Herefordshire Local Plan

Hereford Area Plan

Housing and Employment Site Options Consultation

Technical Site Assessments - North East Hereford

Ayl01

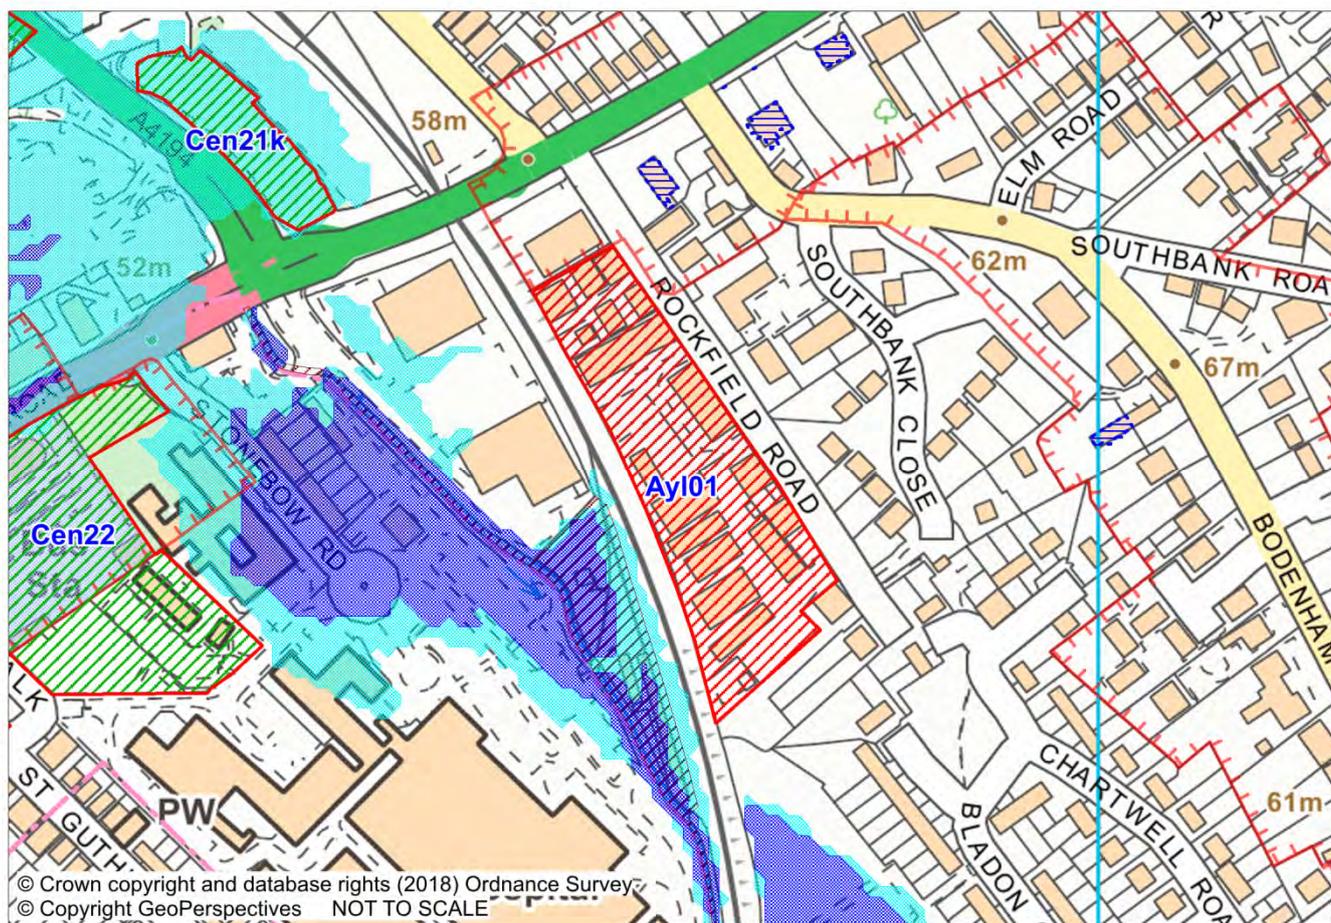
HC Highways comments
Public Transport accessibility comments
<i>Are standards for access to local services likely to be achievable?</i> The site is close to employment areas, city centre, public transport (bus and rail) and other facilities. There is a lack of footways along the access road into the area which would need to be addressed.
Access comments
The access would be via Rockfield Road which has been recently widened for the initial length from Aylestone Hill past the Ron Smith building. The site may be suited to hospital worker accommodation due to the proximity to the hospital site, particularly if a footbridge were provided between the two sites.
Local network comments
<i>Any capacity concerns on this section of the network?</i> The junction with Aylestone Hill and Barrs Court Road is very busy with limited stacking for right turners, but the traffic generation is unlikely to be greater than the current employment uses, albeit possibly reversed in the peak hours. This would need to be covered in a Transport Assessment/Statement comparing vehicle movements and as with all HAP sites the scope and developments to be considered will need to be confirmed.

Site dependence on Hereford Transport Package
HTP may create additional capacity on the highway network.
Mitigation measures
None, except footway provision.
Highway site support
Yes if network impact is acceptable.

HC Conservation comments
Built conservation
The site is partially situated within a Conservation Area, as such any development should preserve or enhance the character and appearance of the CA. The setting of the listed building to the NE of the site should also be considered. Development on the site is not precluded on built heritage grounds.
Archaeology
Likely to be suitable, subject to acceptable prior assessment etc. under NPPF Para 128. This site, which is partly in a Conservation Area, and next to the designated [Hereford] Area of Archaeological Importance, has been greatly disturbed at upper levels by the current industrial land use. It is unlikely to contain well preserved archaeological remains, except perhaps at depth. Archaeological assessment would need to consider the paleo-environmental interest, and the possibility of buried deposits of interest relating to the former river courses along the western fringe. However, none of these issues is likely to be particularly challenging in the round.

Biodiversity/Ecology	
HRA – River Wye SAC/SSSI	
All foul water should be managed through connection to main sewer network. Confirmation that this is possible and also acceptable to Welsh Water is necessary. No direct discharge of any foul water outfall from any onsite treatment system in to any watercourse or culvert will be considered acceptable. All surface water will need to be managed on site through a Sustainable Drainage system (SuDS).	
Protected Species (in line with NPPF, NERC Act, Core Strategy LD1-3)	
Any demolition of existing building or structure or significant site clearance of vegetation will trigger a requirement for an Ecological Survey.	
Open Space requirements	<i>For assessment if appropriate</i>
Development Management	
The Employment Land Study (ELS) and appendices assesses the quality of the employment site (1.42ha) and rates it overall as Moderate. Policy E2 confirms that employment land and buildings rated as ‘best’ and ‘good’ using the ELS methodology will be safeguarded from redevelopment to non-employment uses whereas ‘moderate’ sites can be redeveloped subject to fulfilment of 1 or more of the 3 listed criteria at E2. This is, however, subject to a marketing exercise of at least 12 months where the change of use of Class B land and buildings is proposed.

Rockfield Road seems to be relatively well occupied and there is almost certainly a requirement for more moderate rated (and thus affordable) commercial units within the city centre. However, if the loss of this land to employment were sanctioned, then subject to resolution of other constraints (rail noise, contamination and vehicular access spring to mind), the principle of redevelopment for residential use would be acceptable in principle.

Conclusion			
The site is surrounded by residential to north, south and east, the county hospital and railway line to the west. There is a protected wildlife site on the west side of the railway. There is also a high flood risk on the other side of the railway line as well as surface water flooding on site. There would be matters to be addressed with regard to site access such as footpath provision as well as possible traffic generation as a result of housing instead of employment on the site.			
Due to the site’s proximity to the railway noise may be an issue as well as possible contamination would need to be assessed. Nevertheless, at this stage, there are no fundamental technical issues to prevent the site coming forward for housing.			
However, the site seems to be well occupied and after a Land Registry search, there are 18 separate owners on the site. Due to the multiple ownership situation, land assembly of the site would be unfavourable. There is currently no availability information on the site. If however information did come forward then a review of the site would be necessary. For the purposes of the HAP Site Option consultation the site is considered to have no potential.

Ayl14

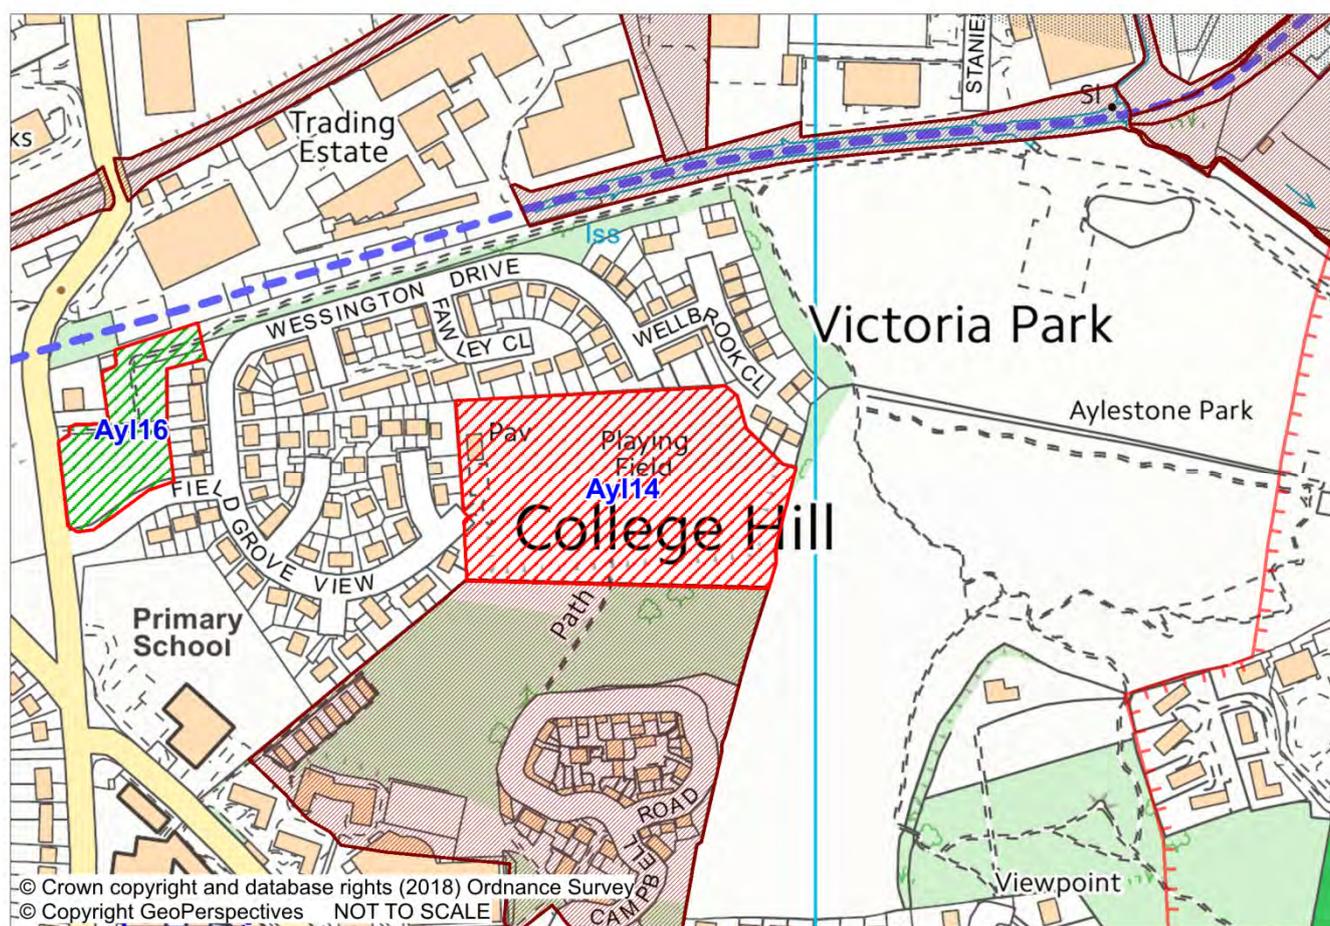
HC Highways comments
Public Transport accessibility comments
<i>Are standards for access to local services likely to be achievable?</i> Yes. Footways available to College Road and onwards from there, but College Road bridge has no footway to access the employment areas to the north. Bus services available on College Road/Venns Lane.
Access comments
The site would be accessed off an existing residential estate road (Field Grove View), which should be able to be extended to serve a development here (subject to highway extents confirmation) and should be of sufficient width to accommodate additional dwellings, but depending upon numbers proposed here and Ayl 16 site.
Local network comments
<i>Any capacity concerns on this section of the network?</i> Not directly for a small development such as this, but overall picture and Strategic Site delivery needs to be given consideration. Signalised railway bridge on A4103 suffers queueing at peak times and College Road bridge has no footway to access the employment areas to the north. The network impact would need to be covered in a Transport Assessment/Statement comparing vehicle movements and as with all HAP sites the scope and developments to be considered will need to be confirmed.

Site dependence on Hereford Transport Package
Yes, for overall network capacity.
Mitigation measures
None locally. Railway bridge on A4103.
Highway site support
Dependent upon available network capacity, site would be considered suitable.

HC Conservation comments
Built conservation
<i>No comments</i>
Archaeology
Suitable. This site has been subject to a considerable amount of prior disturbance, and is regarded as having negligible archaeological interest.
Biodiversity/Ecology
HRA – River Wye SAC/SSSI
All foul water should be managed through connection to main sewer network. Confirmation that this is possible and also acceptable to Welsh Water is necessary. No direct discharge of any foul water outfall from any onsite treatment

The site (Central Park) is now used by United in the Community Football Club (UITC). As of May 2016 they have a 25 year lease from the Landlord: Herefordshire Council: Expiry: July 2041. The provision of this facility for UITC has had a positive impact on improving deficits in junior football facilities in Hereford as identified in the playing pitch assessment for Hereford and the outdoor sports investment plan supported by the FA and HFA (Herefordshire Football Association) as a priority.

If the site was deemed to have potential for housing site then a new site would be required to accommodate UITC including both the existing facilities and the ability to meet the short and long term priorities. Aylestone Park could possibly provide a site but it will be very costly (which is why it has not been developed to date) as there is no existing infrastructure in place other than an access road and car-park.

Well contained site that could be readily assimilated into the residential developments to the north and east. Existing mature trees bank form the boundary to the south. Key issue is the loss of public open space / playing pitch provision (although privately managed so no public access). Some surface water flood risk issues locally on access roads.

The site is mainly surrounded by residential and parkland. It is largely a level parcel of land currently used as open space /football pitches. Access to the site is via Field Grove View into a car park. Overall site accessibility is possible with footway provision and nearby bus service.

The site does not pose significant problems in terms of access and will not have significant impact on historic assets. However, since being identified in the previous housing potential study, the site has become an important local community asset for the United in the Community Football Club (UITC). The club has a long term lease on the site for 25 years. The club has identified a programme of works including short term and long term priorities to improve both the pitches and associated facilities. These proposals are both supported by the HFA and HC as part of the wider outdoor sports partnership. Investment in the site is also taking place. Given the community benefit the site offers the site would be undesirable to take forward for housing in the Site Options.

Ayl15

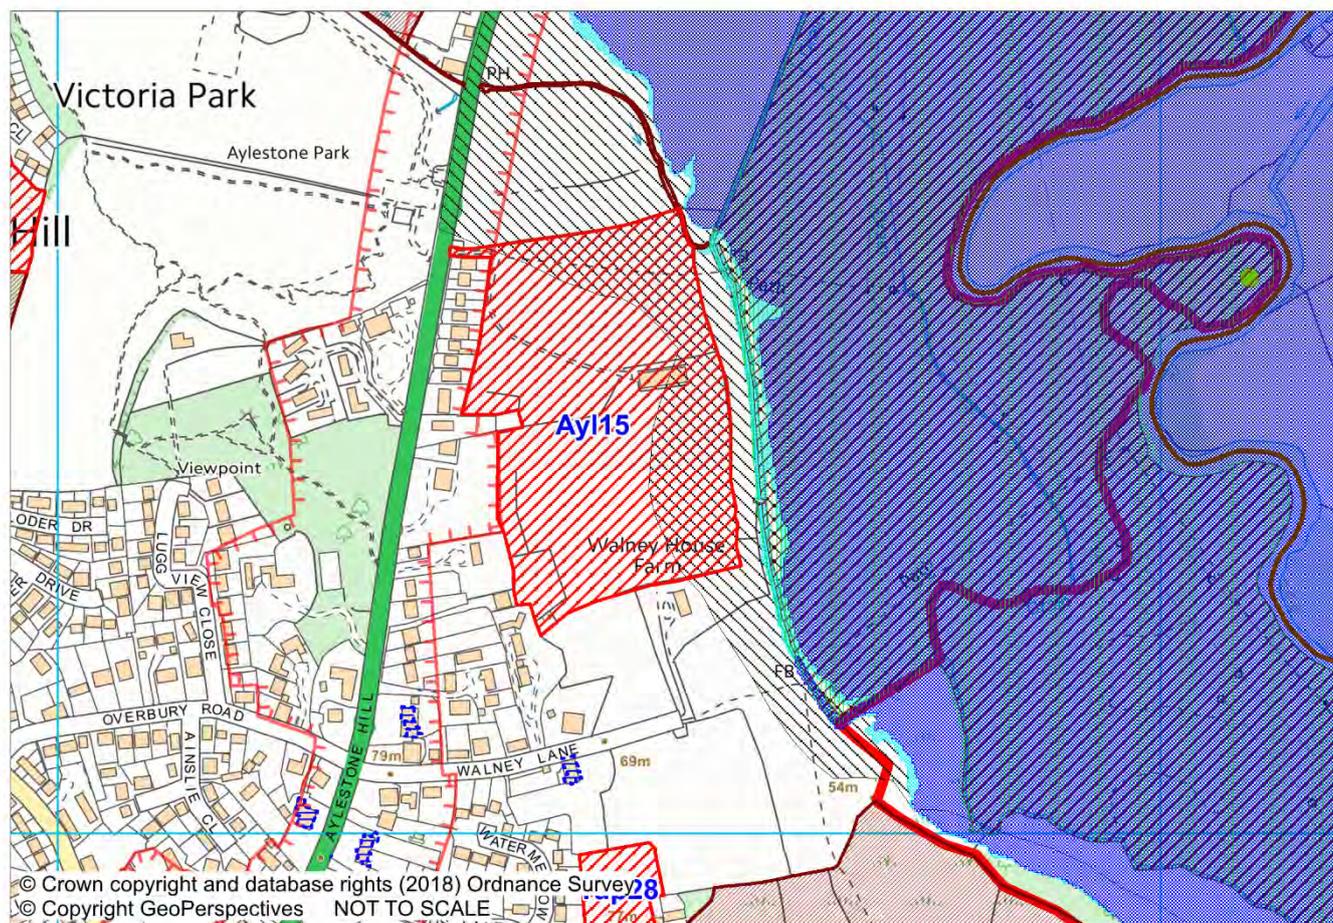
HC Highways comments
Public Transport/accessibility comments
<i>Are standards for access to local services likely to be achievable?</i> Yes. Bus services, cycle and pedestrian routes available on Aylestone Hill.
Access comments
Access would be achievable by way of a new junction combined with the access to Aylestone Park, as submitted for the previous application.
Local network comments
<i>Any capacity concerns on this section of the network?</i> This site has been the subject of a previous application (140963) for housing which was refused and dismissed at appeal. In terms of highways impact, at the time the impact was assessed in a Transport Assessment and considered acceptable. The Transport Assessment would need bringing up to date, with the city link road most likely being open in the current situation, but depending upon the likely date of application submission and with other interim development included, to ensure that the proposals remain acceptable. Aylestone Hill into the city centre suffers from queuing at peak hours and the impact of the new city link road does not appear to have reduced this. As with all HAP sites, the scope and developments to be considered will need to be confirmed.

Site dependence on Hereford Transport Package
Possibly, if capacity not available on the highway network.
Mitigation measures
Dependent upon the outcome of updated Transport Assessment.
Highway site support
Subject to satisfactory Transport Assessment analysis and acceptability of the impact on the network the site would be considered acceptable.

HC Landscape comments
The site has had previous landscape commentary based on a past application and appeal decision. The Inspector concluded with the following in relation to the landscape issues on the site. The site lies on the edge of the Principal Settled Farmlands landscape character type and it has close association with the adjacent Riverside Meadows. The Historic Landscape Characterisation gives primacy to urbanising influences whereas the Urban Fringe Sensitivity Analysis identifies it as having high sensitivity in landscape terms. In reality the site is neither entirely urban nor wholly rural. It lies between the two but, given the manner in which development at Aylestone Hill, when viewed from the meadows, is embraced and largely subsumed by the landscape, the lasting impression is that the appeal site has far greater affinity to the countryside than it does to the City. On this basis the proposed development would have a moderate adverse impact on the character of the landscape, with particular reference to the Riverside Meadows and a very significant harmful impact on views from the meadows within the vicinity of the appeal site. These were the reasons for dismissing the appeal.

HC Conservation comments	
Built conservation	
In relation to impacts upon the Conservation Area, there may be the potential for some development on the site, provided that the statutorily desirable object of preserving and enhancing the area is met.	
Archaeology	
May be suitable, subject to acceptable assessment and evaluation under NPPF Para 128. This is a comparatively large site for its location, and prominent in the landscape. There are records in the locality suggestive of some archaeological potential, so it would be necessary for a desk-based assessment and field evaluation to be provided in relation to proposals here. There is nothing currently known that would represent a major constraint, but there are risks here.	
Biodiversity/Ecology	
HRA – River Wye SAC/SSSI	
All foul water should be managed through connection to main sewer network. Confirmation that this is possible and also acceptable to Welsh Water is necessary. No direct discharge of any foul water outfall from any onsite treatment system in to any watercourse or culvert will be considered acceptable. All surface water will need to be managed on site through a Sustainable Drainage system (SuDS).

Since then the landowner has made a separate enquiry regarding the site's suitability for housing and this, in the light of the highly material appeal decision, has also been resisted. This is in the context that to allow anything (even something significantly reduced) would erode the function of this 'zone of transition' and bring future development pressure to bear.

Conclusion			
<p>The site is currently pasture land on the eastern edge of the city. It is adjoined by residential on its western boundary with mainly open fields on all other boundaries.</p> <p>The site is identified as having mineral reserves of sand and gravel therefore the current saved UDP policy M5 applies. However, the British Geological Survey GeoIndex (onshore) mapping is considered to be a more up to date record of reserve locations. This mapping system does not identify any reserves in this location.</p> <p>There are no significant issues with regard to accessibility or historic impacts surrounding the site. However, the issues regarding landscape are so significant that the site was dismissed at appeal for housing development in the 2016 appeal decision. Having regard to the context that the appeal was decided within i.e. a more perilous housing land supply position than exists presently; the landscape matters are still deemed to have high sensitivity and development would not be suitable in this location. Therefore the site is not suitable to take forward in the Site Options.</p>

Ayl16

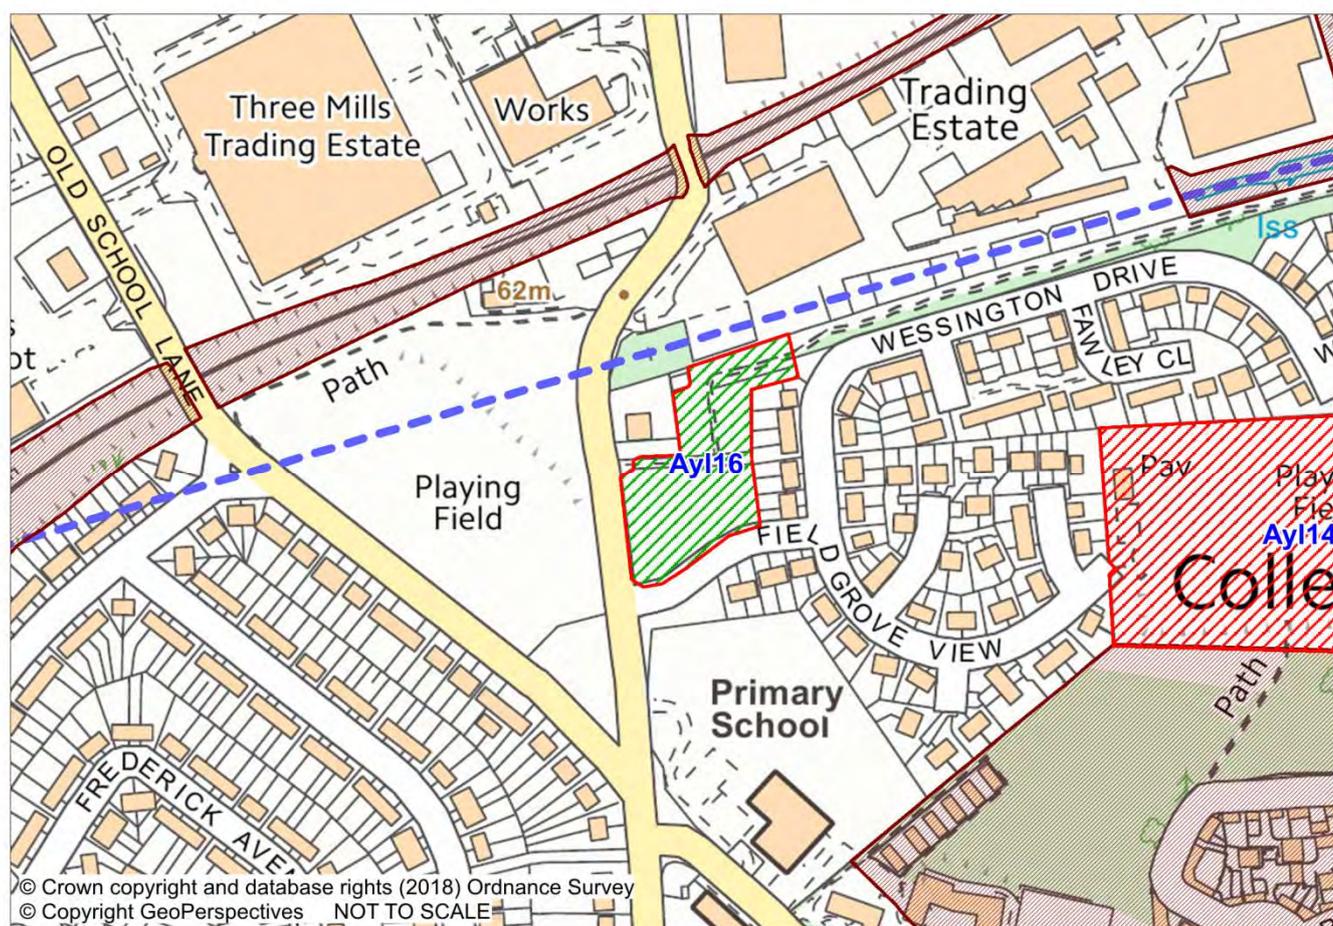
HC Highways comments
Public Transport accessibility comments
<i>Are standards for access to local services likely to be achievable?</i> Site is in a sustainable location. Bus services are available on College Road. Shops are available on College Green. A pedestrian cycleway would need to be provided to maintain continuity of the existing route from College Road to Aylestone Park which runs to the north of Wessington Drive.
Access comments
The site would be accessed off Field Grove Road which should be of sufficient standard to serve additional properties, subject to total numbers here and AYL14 site, which would also be served by this road.
Local network comments
<i>Any capacity concerns on this section of the network?</i> An overall assessment of the acceptability with regard to highway network capacity will need to be carried out (once all sites are reviewed and shortlisted) to assess the cumulative impact and at which stage of the HTP those developments can be brought forward.

Site dependence on Hereford Transport Package
HTP may create more capacity on the network.
Mitigation measures
None available.
Highway site support
Dependent upon network capacity being available, the site would be supported.

HC Conservation comments
Built conservation
There are no known built heritage constraints.
Archaeology
Likely to be suitable. In general, this comparatively small site is of low archaeological potential and there are no real risks. I note the safeguarded route of the former Hereford-Gloucester canal directly adjacent to the north. It would be important under any proposal that this route, and any remains of interest associated with it, are not compromised by the design or layout of development here.
Biodiversity/Ecology
HRA – River Wye SAC/SSSI

Open Space requirements	Area of land or contributions required		
On site	No	Off site	yes
<p>The open space assessment undertaken in 2006 (evidence base produced in accordance with the then national Planning Policy Guidance 17) is still considered to be robust in respect of amenity greenspace, as little has changed. This assessment concluded that there is an over-supply of amenity greenspace in Hereford north in general. This evidence would suggest its loss would be acceptable and in general the residents in this area are well served with open space, including Aylestone Park to the East and Old School Lane to the west, both accessible and offering a range of recreation opportunities.</p> <p>That said, this area does provide an important link in the green infrastructure at this point, providing connectivity to a semi natural footpath that links to Aylestone Park in one direction and access (across a road) to Old School Lane recreation ground in the other. In doing so it also provides part of a valuable wildlife corridor. Any development of this site should therefore be in accordance with policy LD3 which requires development proposals to protect existing green corridors and linkages. This along with the trees on the area which should be retained as part of the green infrastructure corridor may affect the area of developable land.</p> <p>Consultation with the local community would establish its value as open space. Its potential loss or partial loss would need to be publicised locally and compensation considered.</p>

Conclusion			
<p>The site is surrounded by mainly residential gardens to East, and Employment land to North. College Rd runs along the Western boundary with a residential road leading into Field Grove View running along the southern boundary. There is also a High pressure gas main running underground along northern boundary as well as the safeguarded route for the Herefordshire & Gloucestershire Canal.</p> <p>The site is a small existing amenity greenspace. It primarily serves the residents of the Wessington Drive/Field Grove estate as an area for informal recreation/amenity green space. It includes a grouping of semi mature trees which add to the visual amenity of the space.</p> <p>There are no significant issues with regard to highways or impacts on historic assets. A pedestrian cycleway would need to be provided to maintain continuity of the existing route from College Road to Aylestone Park which runs to the north of Wessington Drive. The site is open space in an area well served by existing parks therefore the site is considered surplus. However, there is valuable amenity and green infrastructure within the site which would need to be retained. This will have a bearing on the developable area and the potential site capacity may be less than set out above. For the purposes of the HAP Site Option consultation the site is considered to have potential.</p>
